APPLICATION FOR  
AMENDMENT OF PLAN UNDER SECTION 12A OF  
THE TOWN PLANNING ORDINANCE  
(CAP.131)

For Official Use Only 請勿填寫此欄	Application No. 申請編號	Y/YL-LFS/11
	Date Received 收到日期	28.2.2020

Application No. 申請編號	(For Official Use Only) (請勿填寫此欄)
Location/address 位置/地址	Lots 1966 S.A, 1966 R.P., 1968, 1969, 1970, 1975 R.P., 2024 R.P. (Part) in D.D.129 and Adjoining Government Land, Lau Fau Shan, Yuen Long  元朗流浮山丈量約份第129約地段第1966號A分段、第1966號餘段、第1968號、第1969號、第1970號及第1975號餘段、2024號餘段(部份)和毗連政府土地
Site area 地盤面積	3,335.3 sq. m 平方米 <input checked="" type="checkbox"/> About 約 (includes Government land of 包括政府土地 148.7 sq. m 平方米 <input checked="" type="checkbox"/> About 約)
Plan 圖則	Approved Lau Fau Shan & Tsim Bei Tsui Out Line Zoning Plan No. S/YL-LFS/7 流浮山及尖鼻咀分區計劃大綱核准圖編號 S/YL-LFS/7
Zoning 地帶	"Recreation" 「康樂」
Proposed Amendment(s) 擬議修訂	<input type="checkbox"/> Amend the Covering Notes of the Plan 修訂圖則《註釋》的說明頁  <input type="checkbox"/> Amend the Notes of the zone applicable to the site 修訂適用於申請地點土地用途地帶的《註釋》  <input checked="" type="checkbox"/> Rezone the application site from "Recreation" to "Government, Institution or Community (1)" 把申請地點由「康樂」地帶改劃為「政府、機構或社區(1)」

**Consolidated Planning Report**

## Figure T1 – Shuttle Bus Turnaround Swept Path

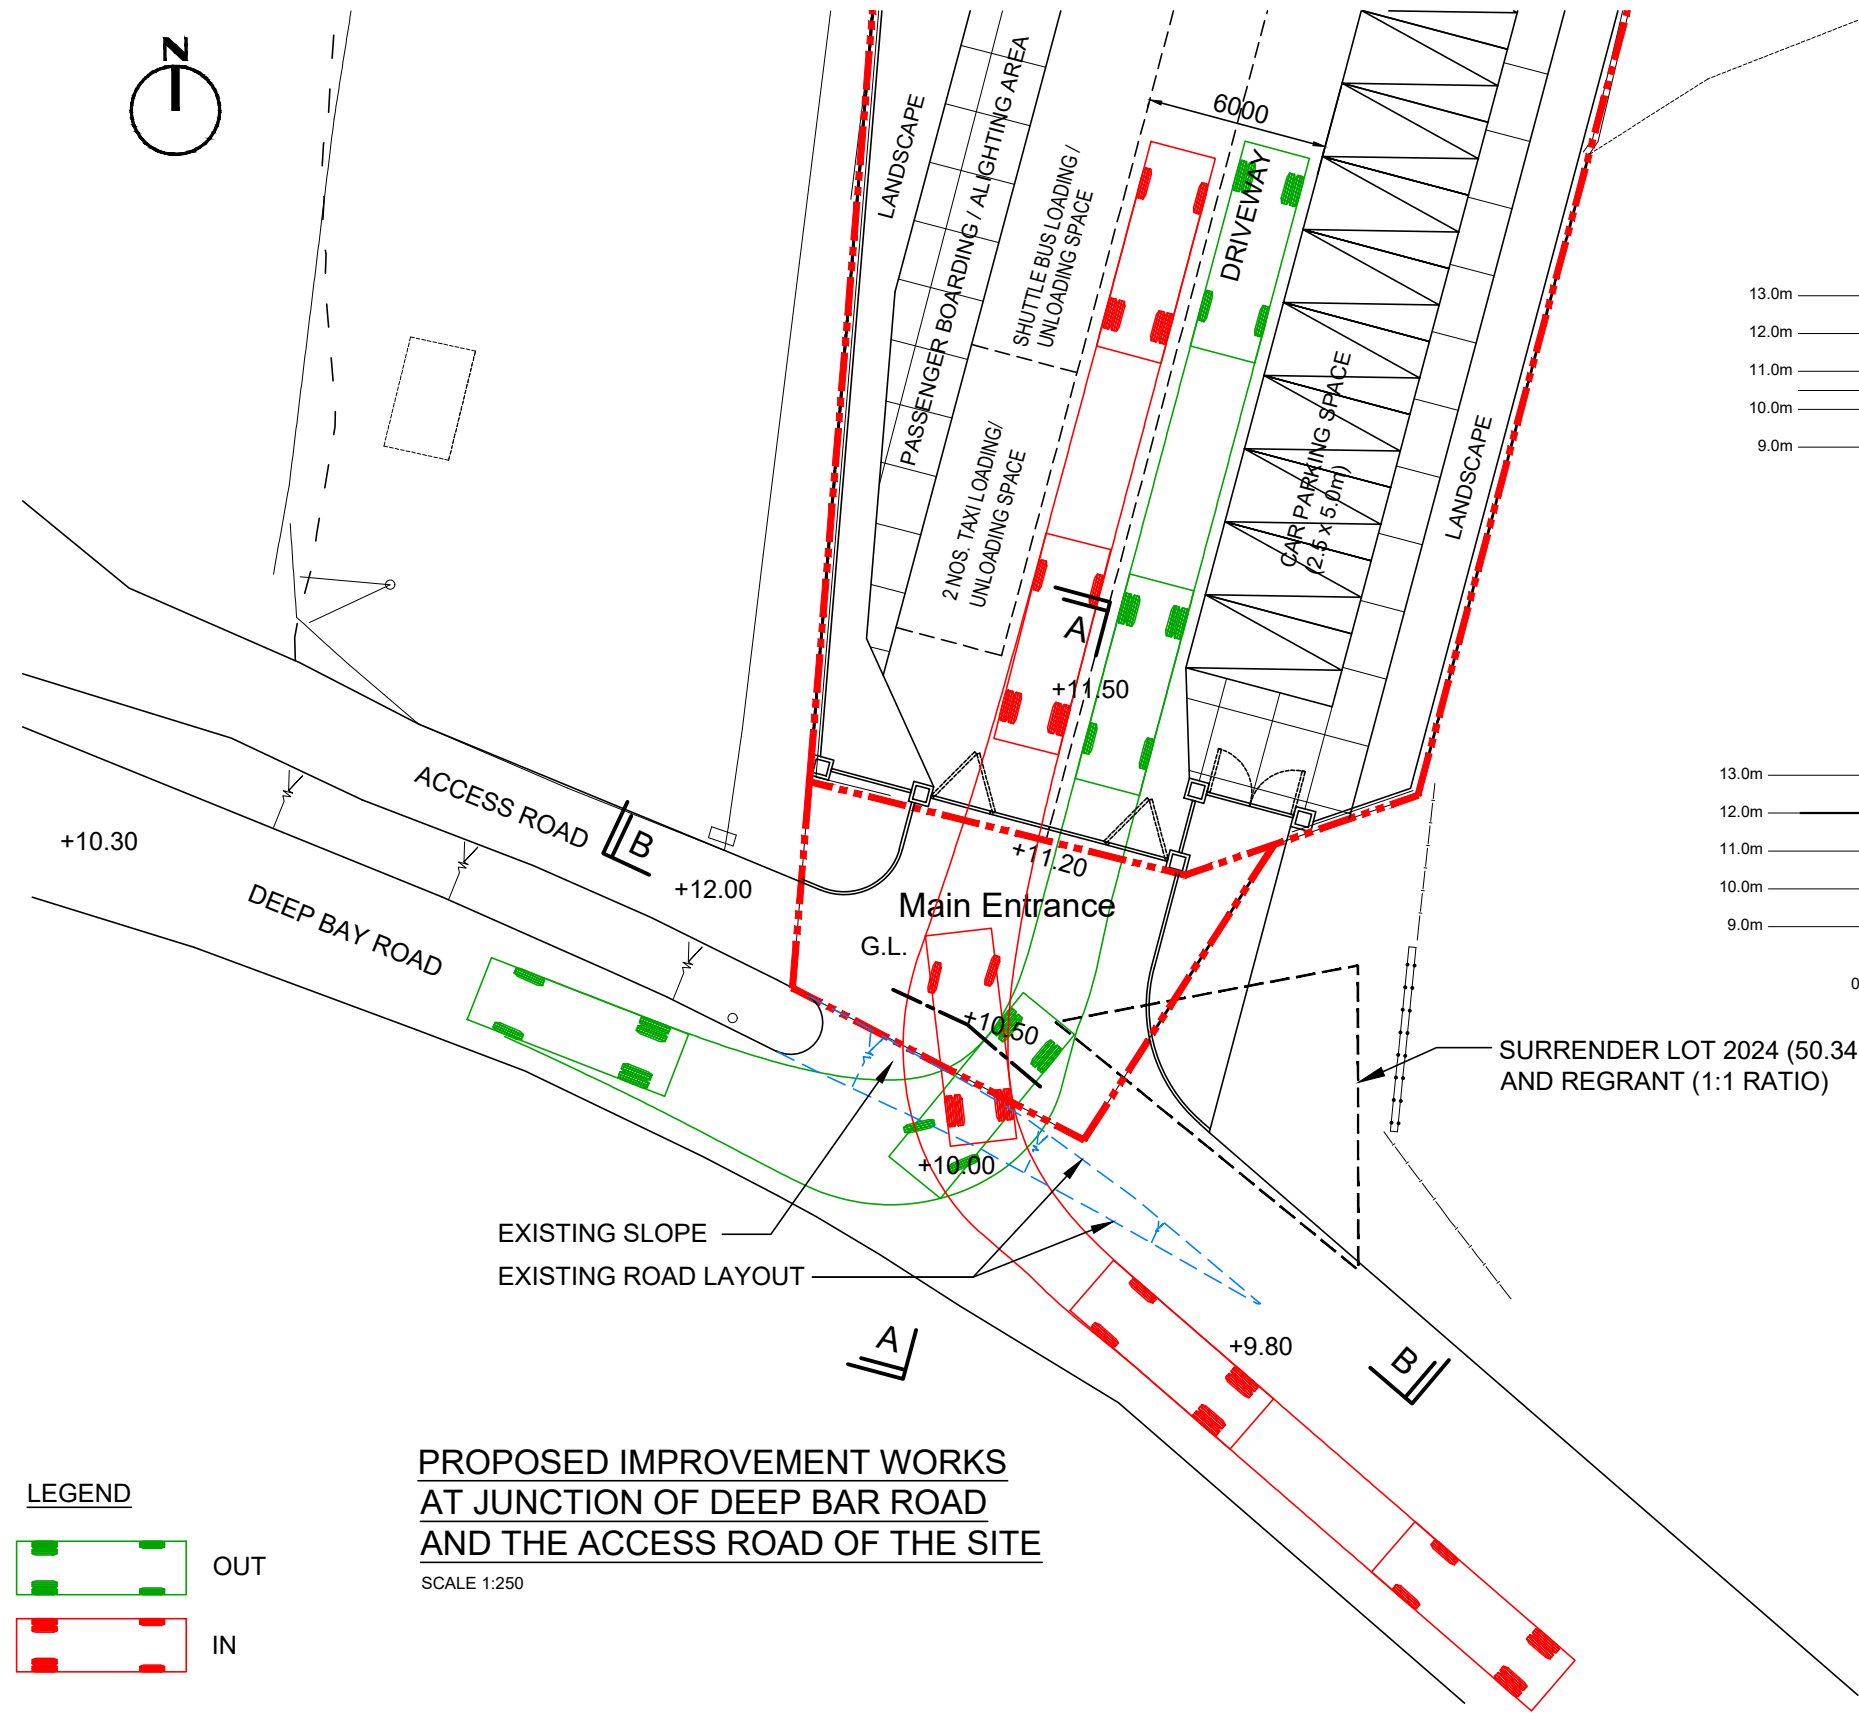
HKPF (B5)	<p><u>Response to comment from the applicant [Item: HKPF (A4)]</u></p> <p>(d) By measurement, the dimension showed in Figure T1 are not on scale which could not reflect the tuning path of a 28-seated minibus in taking U-turn and drive back to the Ingress/Egress of the Site. Comment could not be laid.</p>	A scale bar has been added to <b>Figure T1</b> to facilitate your review attached in <b>Annex A2</b> of the Consolidated TIA report in <b>Appendix IV</b> . As shown in the figure, the swept path analysis has demonstrated adequate turn-around area for the 7.7m shuttle bus.
HKPF (B6)	<p><u>Response to comment from the applicant [Item: HKPF (A5)]</u></p> <p>(e) The drawings (DWG) No. SP-01 cannot reflect the existing geography condition of the Site, especially in the vicinity of the ingress/ egress of the Site. The slope on DBR opposite to the Ingress/ Egress has not been plotted. On the other hand, the paths of run in and out showed on the DWG are not accurate as the model car is only 5</p>	<p>We would like to clarify that the scale of SP-01 should read 1:250 in A3 size, drawing has been re-printed to scale and attached in <b>Appendix IV</b>.</p> <p>The Applicant has proposed to improve the entrance area to facilitate vehicular ingress and egress through re-alignment of both the vertical and horizontal profiles. Cross</p>

- 2.4.6 About 39m of car/taxi/shuttle bus boarding/alighting area will be provided. As shown on **Figure T1**, the swept path analysis has demonstrated adequate turn-around area for the 7.7m shuttle bus. A traffic circulation system has been recommended to enable vehicles to entering the Site, board/alight passengers and then exit. The 39m of boarding/alighting area would allow simultaneous boarding/alighting of 2 cars/taxis or 4 shuttle minibus without blocking through traffic. Conservatively assuming a 1 minute dwelling time for boarding/alighting per car/taxi, there would be a handling capacity of 900 private cars or taxis per hour (15 vehicles x 60 minutes ÷ 1 minute). Assuming each vehicle carries 3 visitors, this would equal to 2,700 visitors at the peak hour which will well cover the peak demand.
